SUBJECT: REQUEST FOR ADDITIONAL INFORMATION FOR THE BOILING
WATER REACTOR (BWR) VESSEL INTERNALS PROJECT (BWRVIP)-234,
"THERMAL AGING AND NEUTRON EMBRITTLEMENT EVALUATION OF
CAST AUSTENITIC STAINLESS STEEL FOR BWR INTERNALS"
(TAC NO. ME5060)

SECOND REQUEST FOR ADDITIONAL INFORMATION ON BWRVIP-234,

“THERMAL AGING AND NEUTRON EMBRITTLEMENT EVALUATION OF CAST AUSTENITIC
STAINLESS STEEL FOR BWR INTERNALS” (TAC NO. ME5060)

Figure 1. Plot of predicted toughness (J-integral value at 2.5 mm crack extension) from BWRVIP-100 and NUREG/CR-6960 as a function of neutron fluence. The predicted lower-bound toughness of CF-8 due to TE alone is shown for reference.

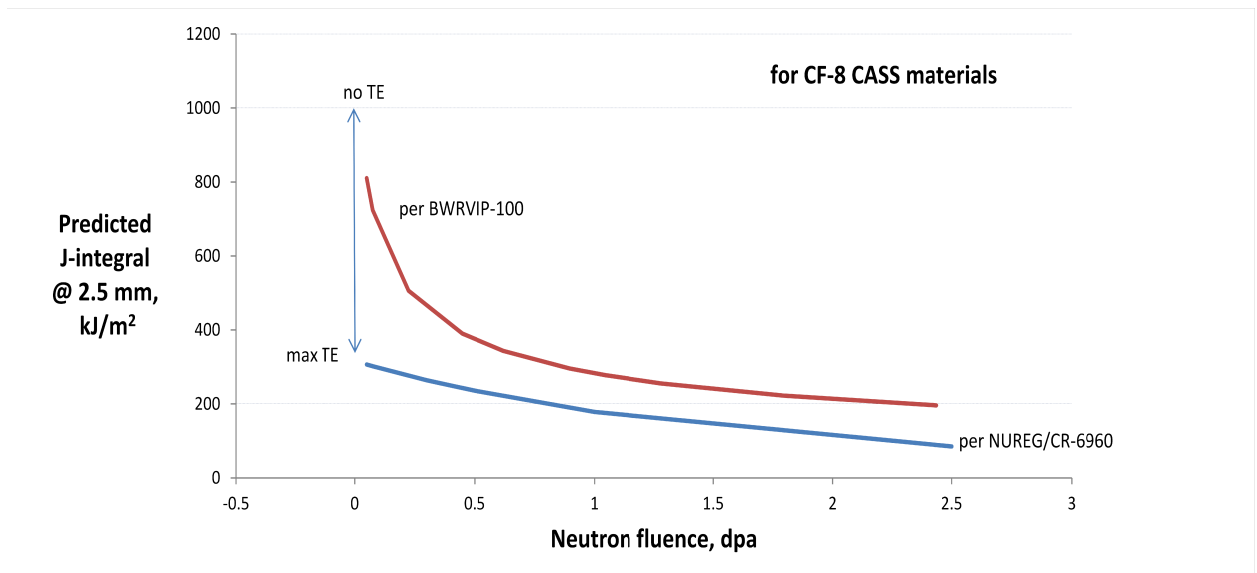
The NRC staff has reviewed the technical bases for the RAI responses and compared the methodology used in BWRVIP-234 to predict fracture toughness as a function of neutron exposure to a previously reported prediction from NUREG/CR-6960. The comparison is shown in Figure 1 along with the range of predicted J values at 2.5 mm crack extension for unirradiated CF-8 with no thermal embrittlement (TE) and maximum TE (no irradiation) for CF-8 with > 15 percent delta ferrite (Section 3.1.1 of NUREG/CR-4513, Rev. 1).

The NRC staff is concerned that the BWRVIP-100 model for CASS may be inadequate for the following reasons:

- The data base for development of the BWRVIP-100 model to predict toughness does not include any CASS materials, just welds, heat affected zone material, and base metal. Further, the number of welds in the database is limited, and the delta ferrite content for these welds is unknown. Welds typically contain 7 to 10 percent ferrite while CASS materials can have between 5 and 25 percent ferrite. Therefore, the toughness predicted by the BWRVIP-100 model may not be appropriate or conservative for CASS materials.

- The NUREG/CR-6960 model is based on data from CASS materials, welds, and wrought materials; therefore, the NRC staff believes it more conservatively represents the fracture toughness of irradiated CASS materials. At fluence values > 0.3 dpa, the toughness predicted by the NUREG/CR-6960 curve is below the value of 255 kJ/m^2 used as the basis for the screening based on toughness in BWRVIP-234.

The NRC staff requests that the BWRVIP review all available data on fracture toughness of irradiated CASS materials, and the associated uncertainties, and to either revise its methodology to predict the lower-bound toughness of CASS materials at reactor operating temperatures after approximately 60 years of operation, or provide further justification that BWRVIP-100 is sufficiently conservative.
